**CITY OF LA VISTA
PLANNING DIVISION**

RECOMMENDATION REPORT

CASE NUMBER: 2013-SUB-06

RE: Application for Replat-Initial Review
Jaycee Park

SARPY COUNTY PRELIMINARY PLAT

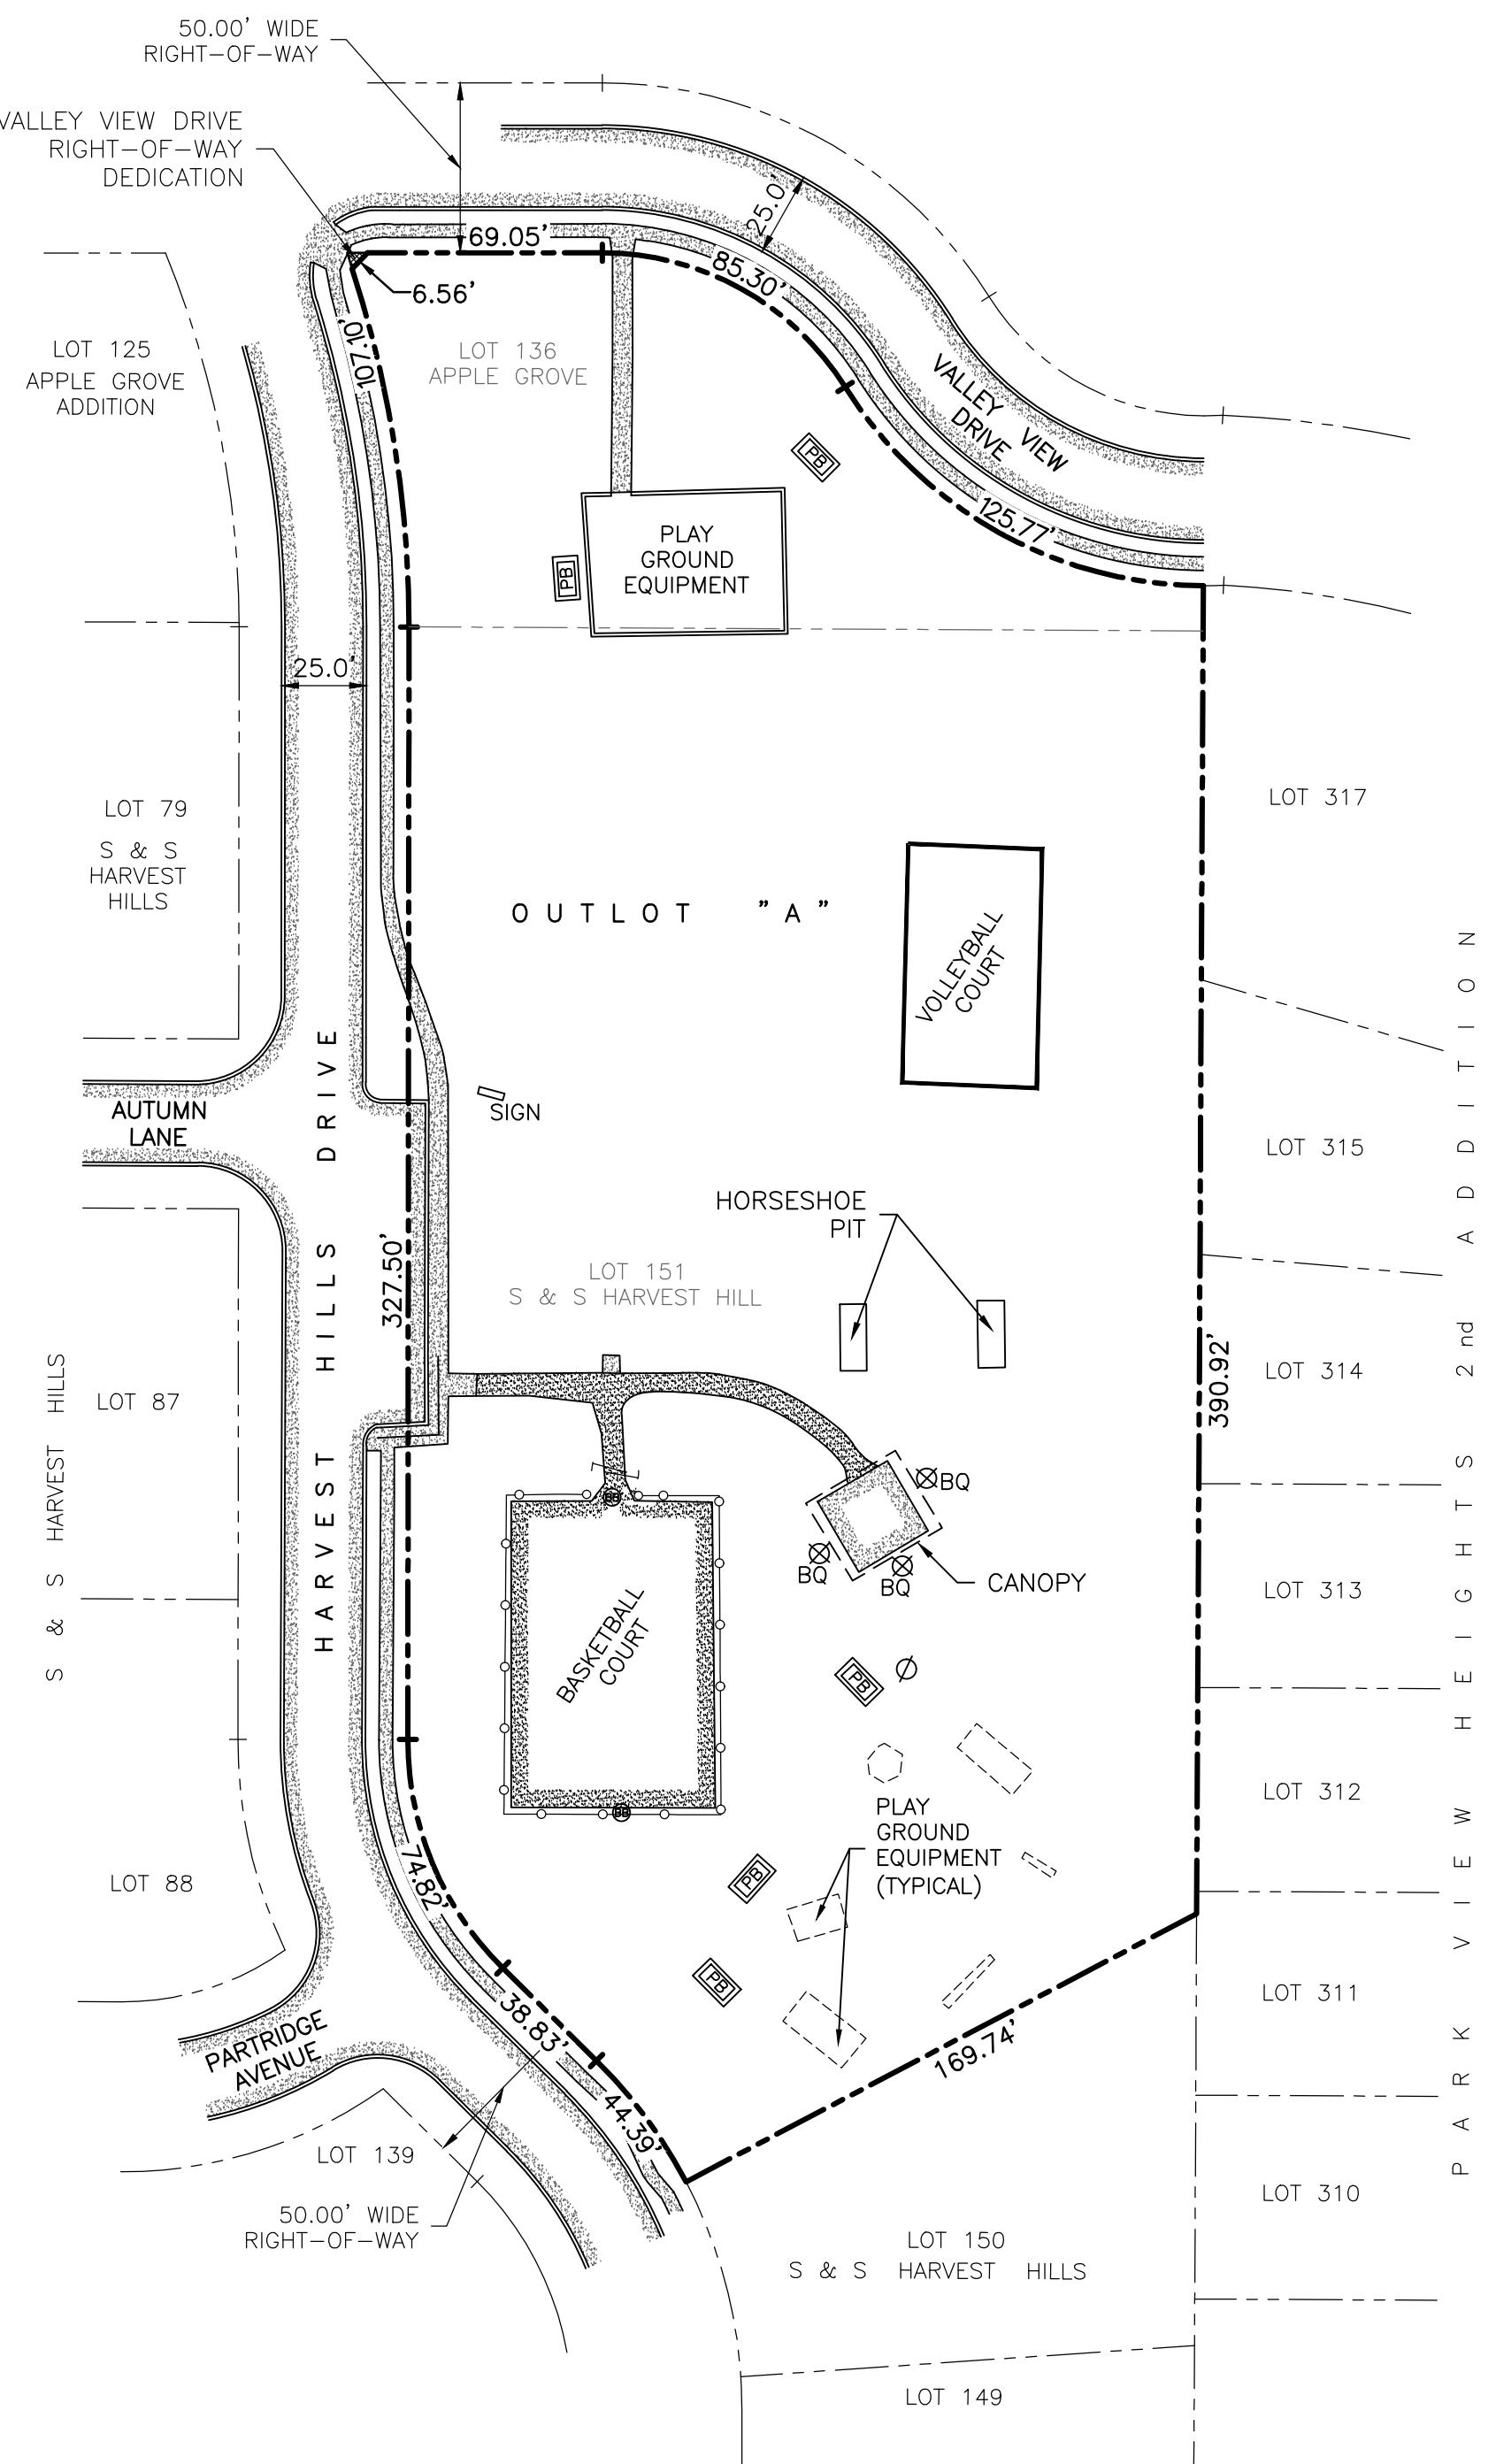
1. The requirements of Article 3.03 of the Subdivision Regulations have been met concerning content of a preliminary plat. There are various items that do not pertain due to the nature of the platting. These include erosion control plans, grading plans, subdivision agreement, etc.

Sheet Title
SARPY COUNTY
FINAL PLAT

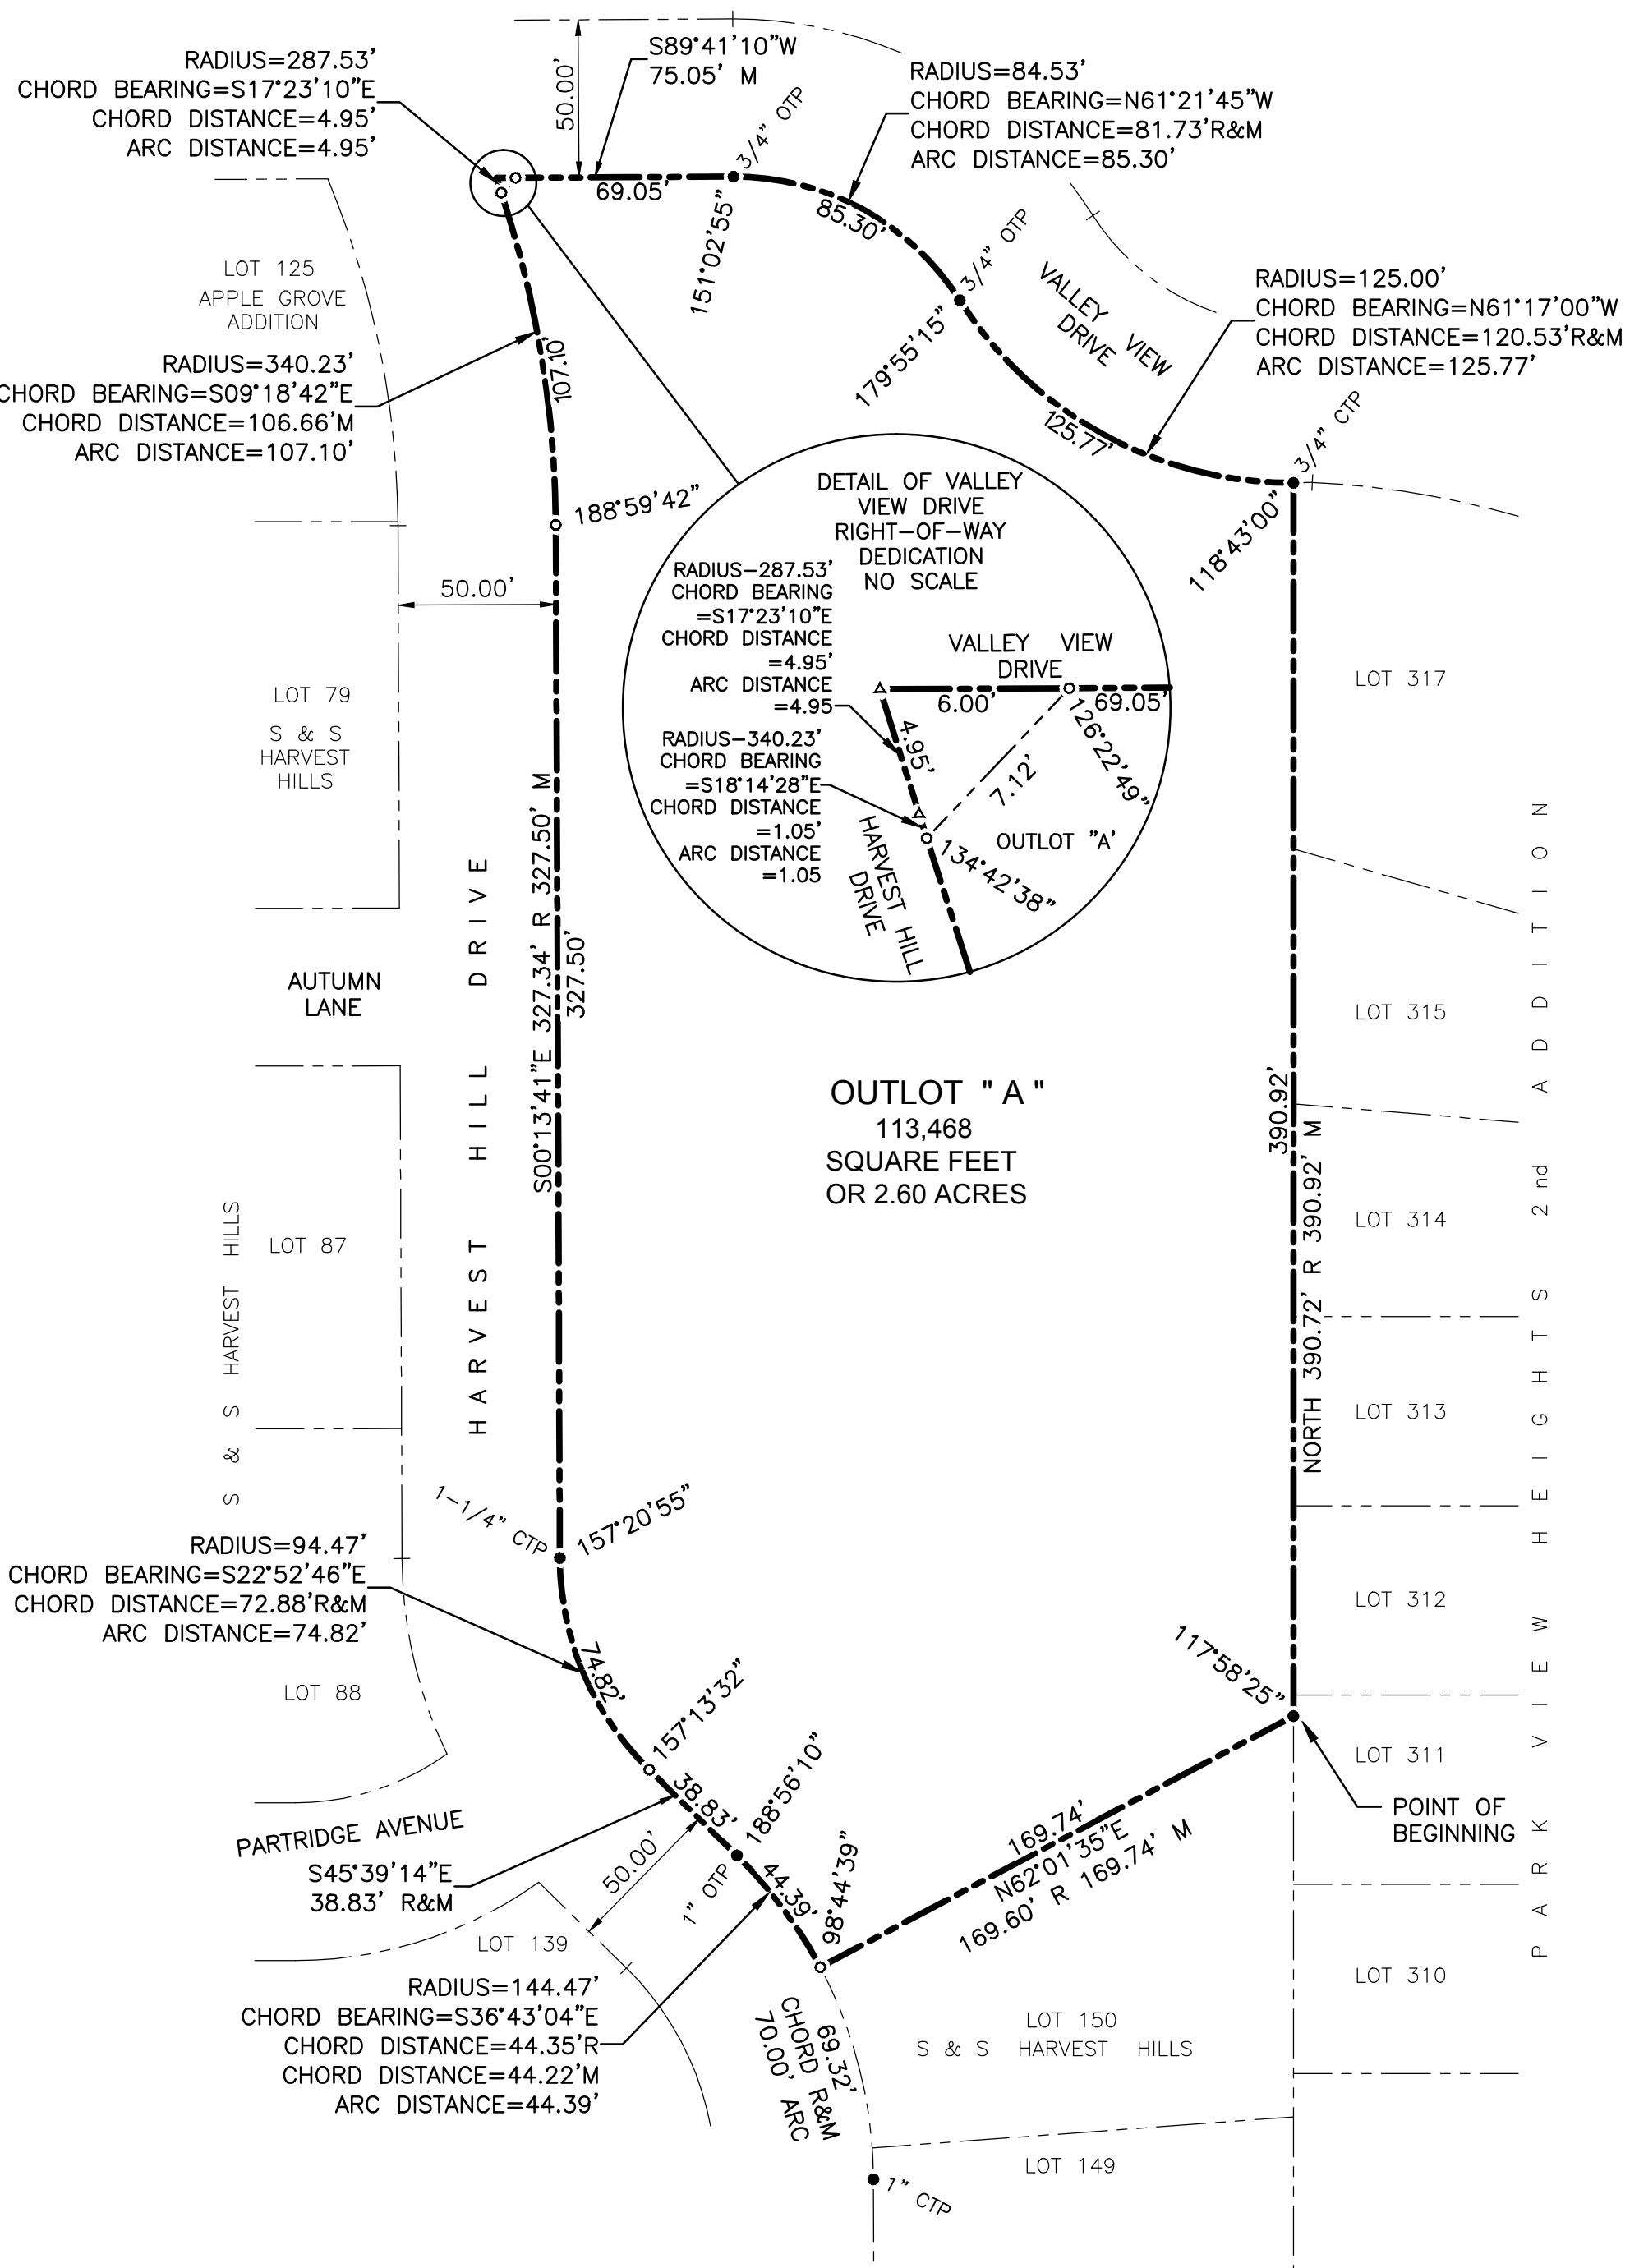
4. The final plat was reviewed for compliance with Section 3.05 of the Subdivision Regulations. Various items are not applicable due to the nature of the replatting. There will be a need to request release of the side lot line easements along the common line between existing Lots 136 and 151. Releases from the affected utility companies need to be obtained by TD2 prior to the final plat mylars being recorded. I understand that utility companies are not processing such release requests until there is evidence of approval of the replat by the City. Therefore, the releases may not be available until after Planning Board and/or City Council approval.
